**ZONING AMENDMENT  
PLANNED UNIT DEVELOPMENT &  
SUBDIVISION STAFF REPORT**

**Date: July 15, 2004**

**DEVELOPMENT NAME** Western Properties Subdivision

**LOCATION** 709 Western Drive  
(Northwest corner of Western Drive and Northwest Drive)

# SITE PLAN

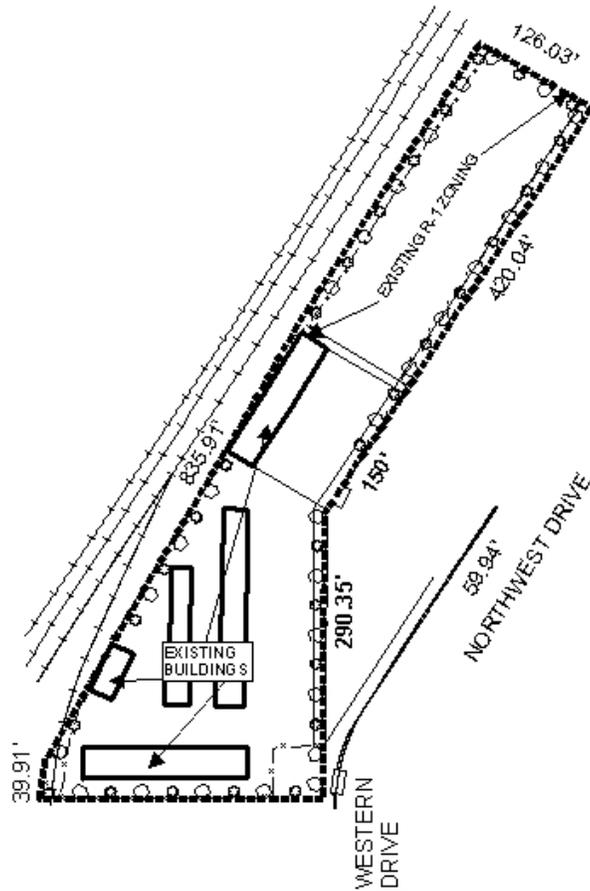
As illustrated on the site plan, it appears that the only proposed change to the property is a new access point to Northwest Drive. However, this driveway would be zoned industrially and as such 18-wheelers would be driving between two existing residential structures. While the current zoning would prohibit a second point of access, redesign/renovation of the existing site, or limiting deliveries to smaller vehicles would allow the passage of emergency vehicles.

*The site plan illustrates a 10-foot buffer strip adjacent to residential development, which is the minimum buffer required by the Zoning Ordinance; this situation (industrial property adjoining residential) would necessitate a minimum buffer of 15-feet, as well as the provision an eight-foot wooden privacy fence.*

*In regard to the proposed PUD, the existing site would essentially remain as is, however, all the parking, access and maneuvering is illustrated as shell. Typically rezoning and PUD approvals require full compliance with all municipal codes and ordinances, including paved parking and landscaping and tree plantings. It should be noted that as a PUD, any changes to the proposed site plan other than specific conditions placed upon this approval would require a new PUD application.*

**Rezoning:** *Based upon the revised site plan, this application is recommended for approval subject to the following conditions: 1) the provision of a 15-foot vegetative buffer and an eight-foot wooden privacy fence where the site adjoins residential development; 2) the paving of all access, maneuvering and driveways; 3) full compliance with the landscaping and tree planting requirements of the Ordinance; and 4) full compliance with all municipal codes and ordinances.*

**Planned Unit Development:** *Based upon the revised site plan, this application is recommended for approval subject to the following conditions: 1) the provision of a 15-foot vegetative buffer and an eight-foot wooden privacy fence where the site adjoins residential development; 2) the paving of all access, maneuvering and driveways; 3) full compliance with the landscaping and tree planting requirements of the Ordinance; and 4) full compliance with all municipal codes and ordinances.*
